MONITORING YEAR 4 ANNUAL REPORT

LONE HICKORY MITIGATION SITE

RE: Lone Hickory Mitigation Site – Monitoring Year 4 Report Draft
Yadkin River Basin – CU# 03040101 – Yadkin County
DMS Project ID No. 97135
Contract # 6897

Figure 3.1 Current Condition Plan View Map (Sheet 1)
 Lone Hickory Mitigation Site
 DMS Project No. 97135
 Monitoring Year 4 - 2022

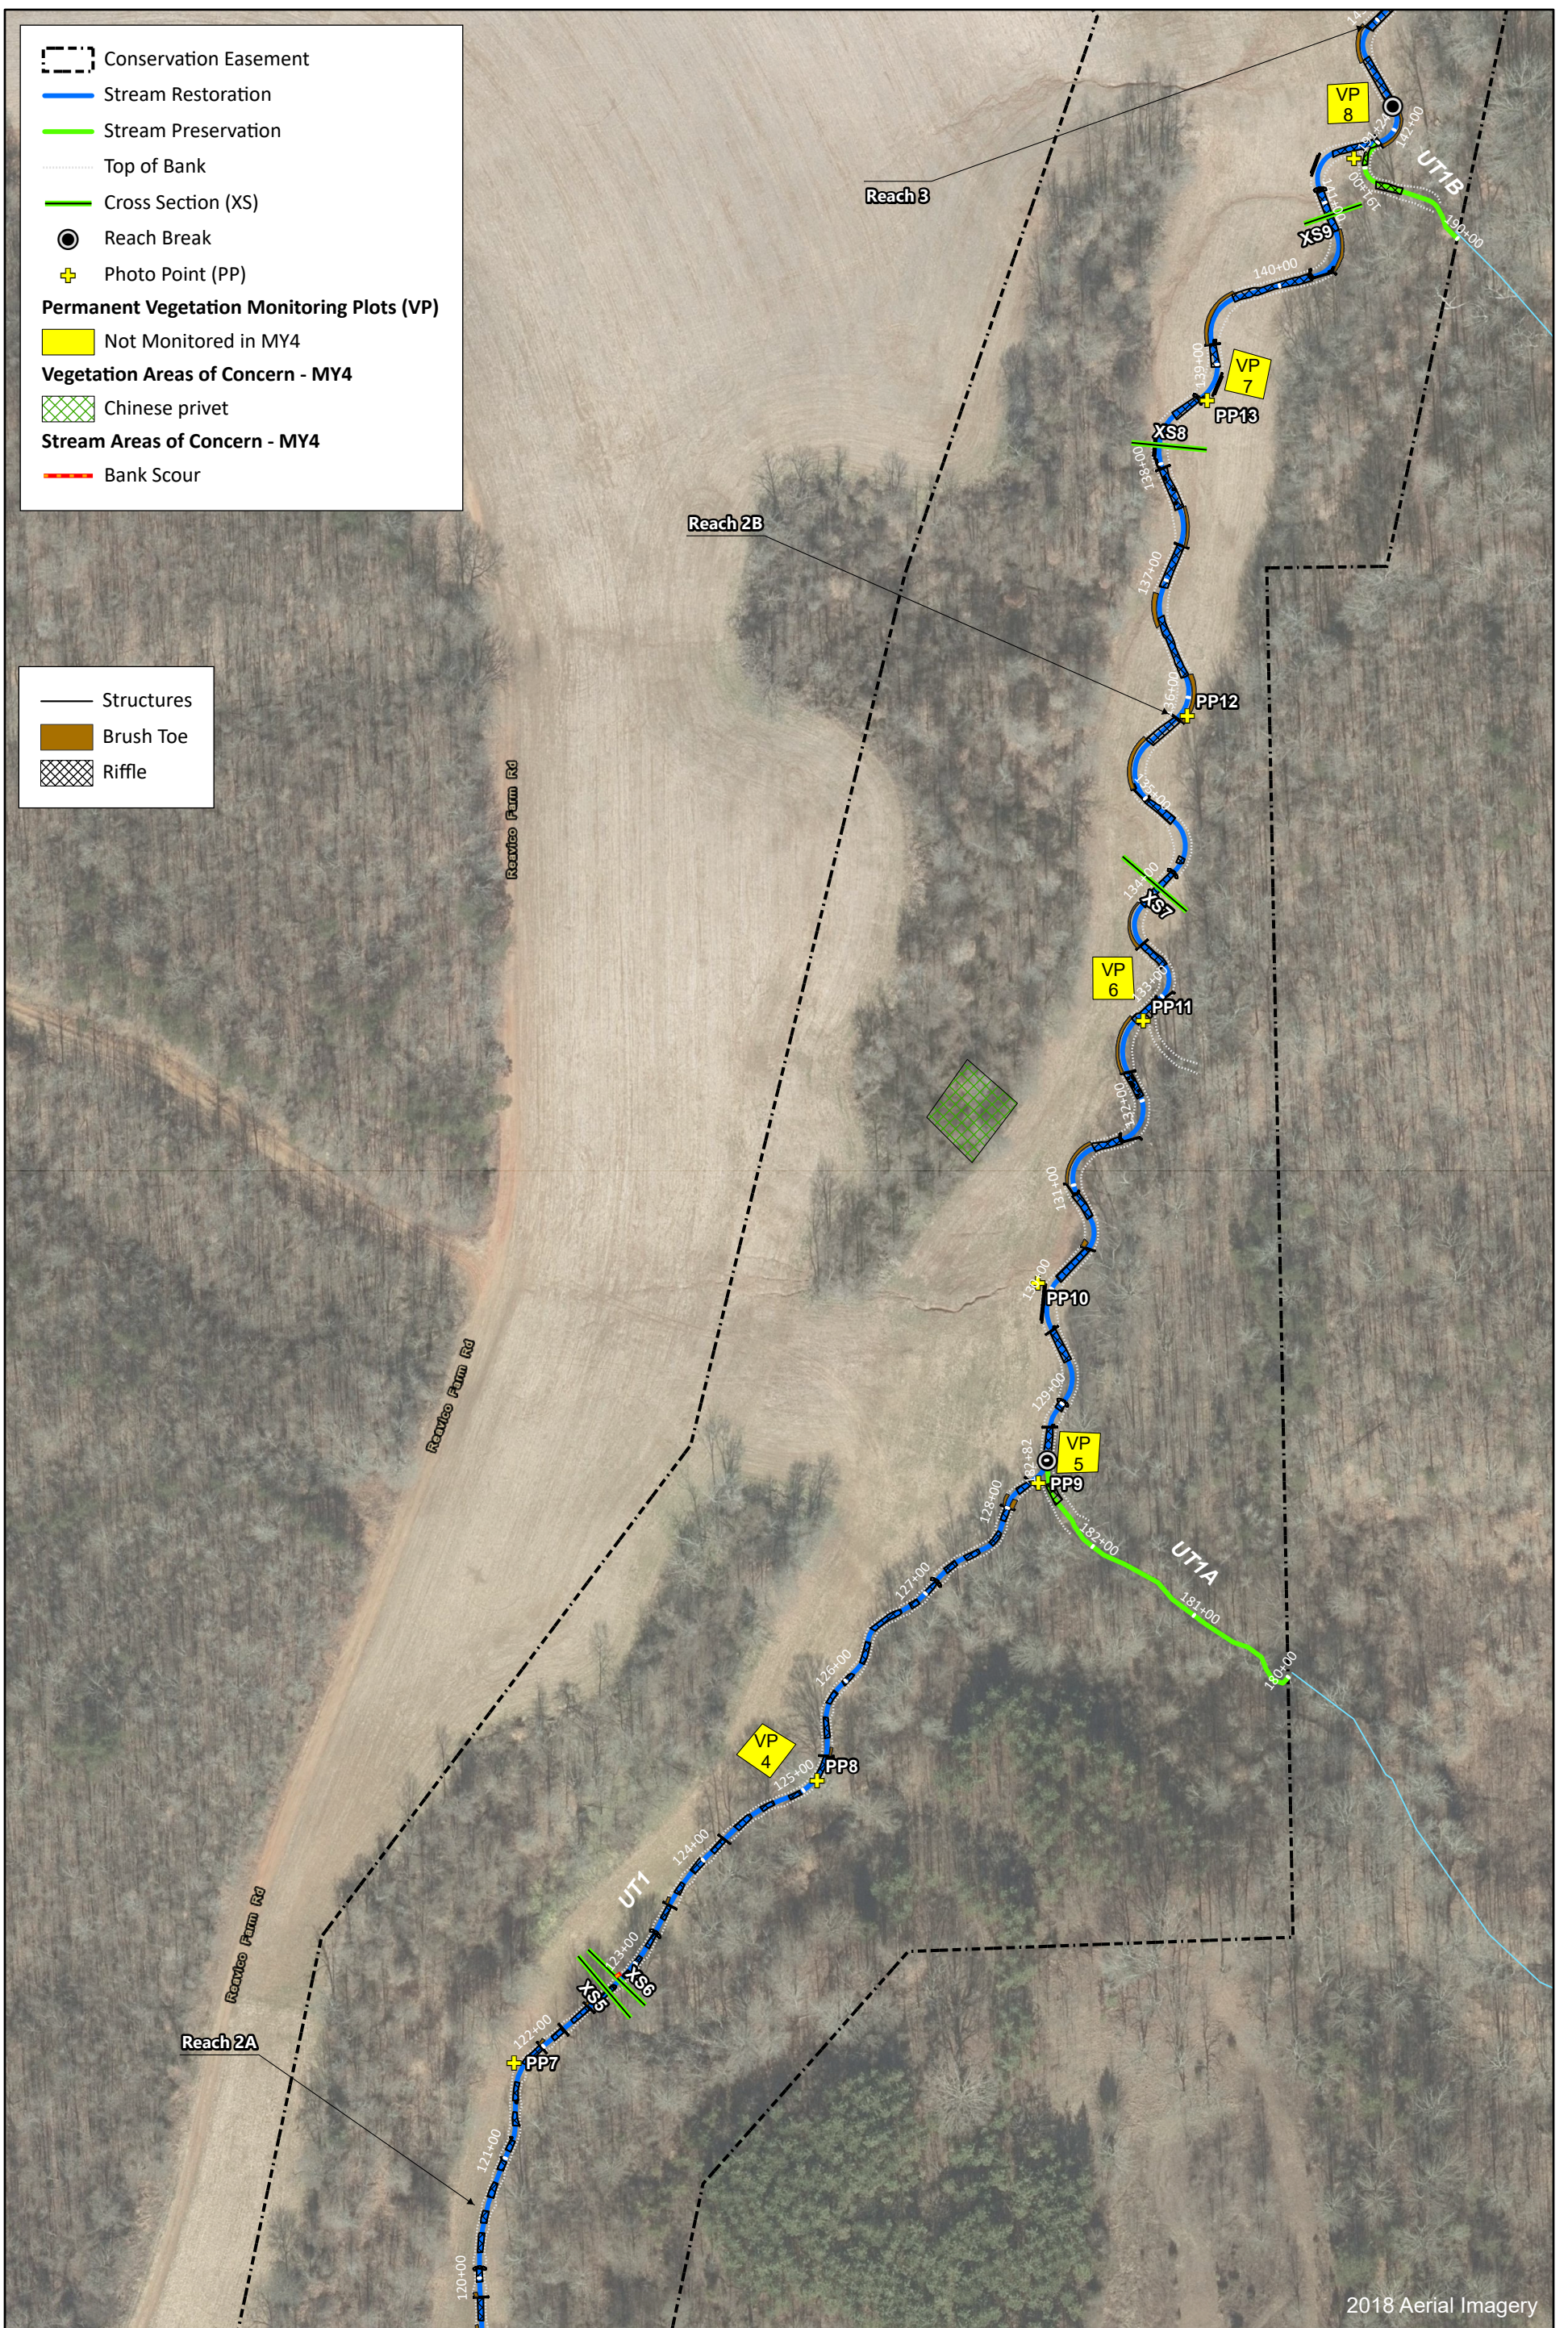
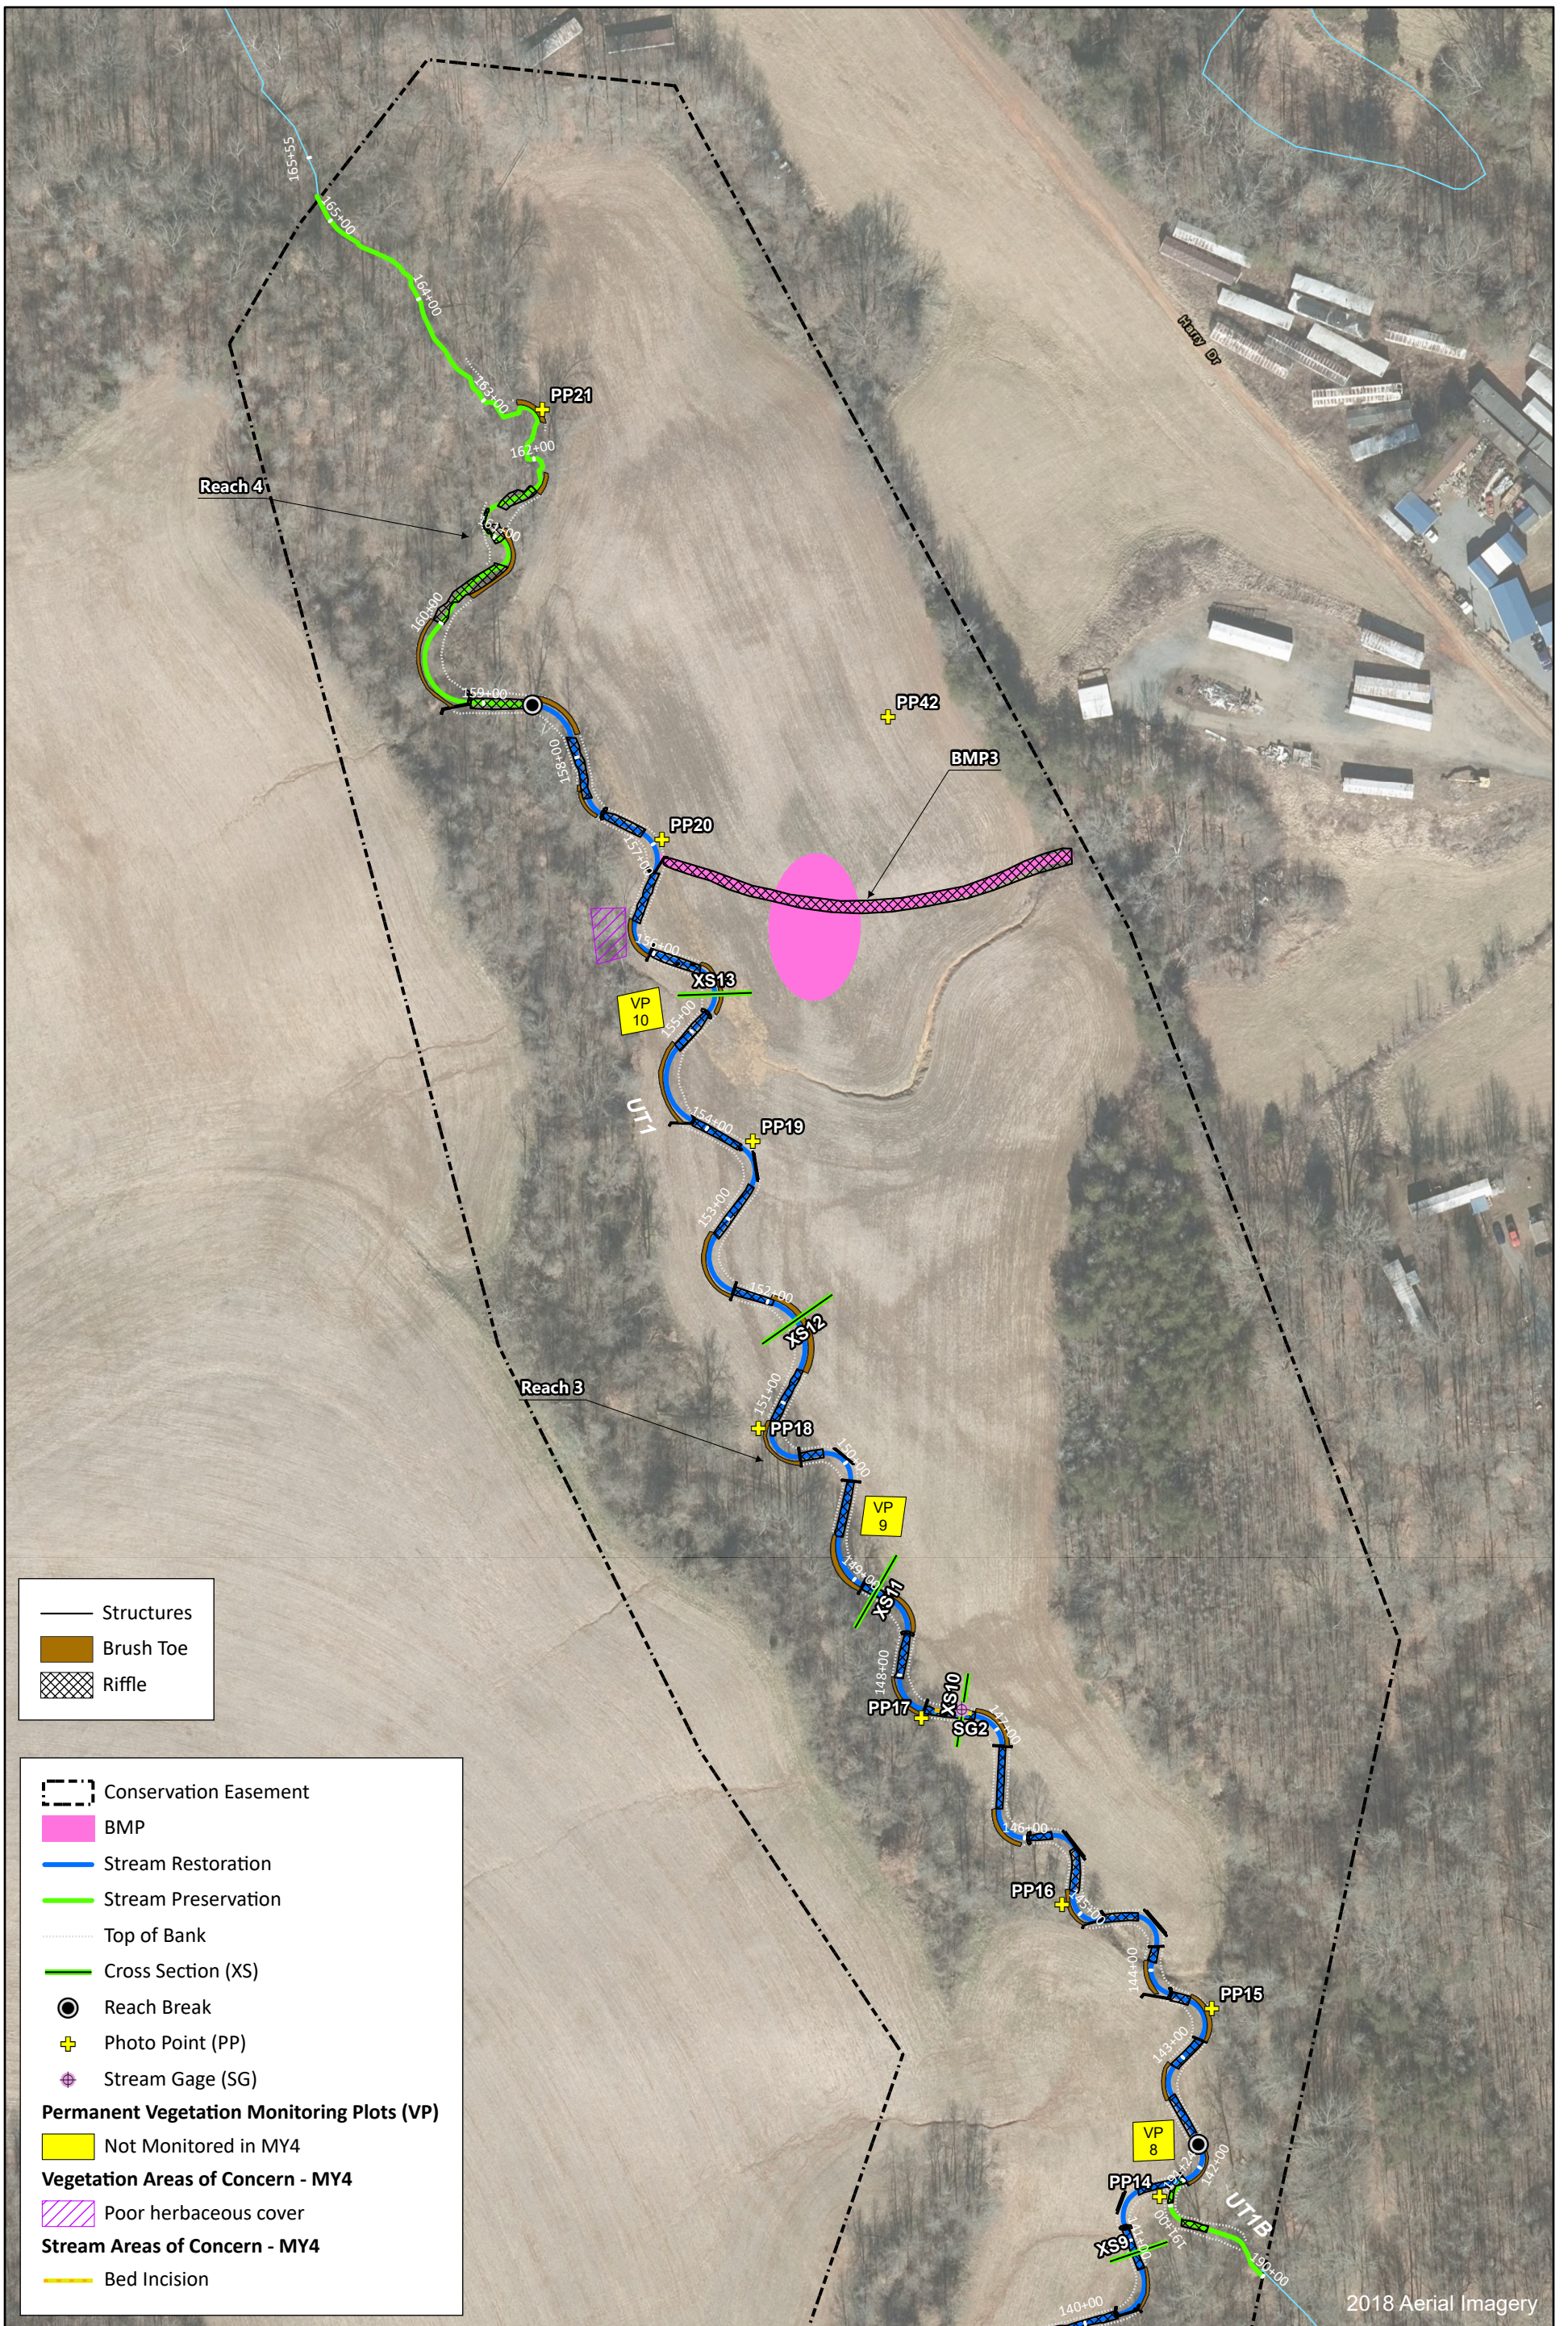
DMS' comment: CCPV Maps: Please show the two (2) established soil temperature probes on the applicable CCPV map sheets and update the digital support files accordingly.

Wildlands' response: The locations of the two soil temperatures probes have been added to the applicable CCPV figures. The digital GIS files have been updated to include the soil temperature probe feature class.
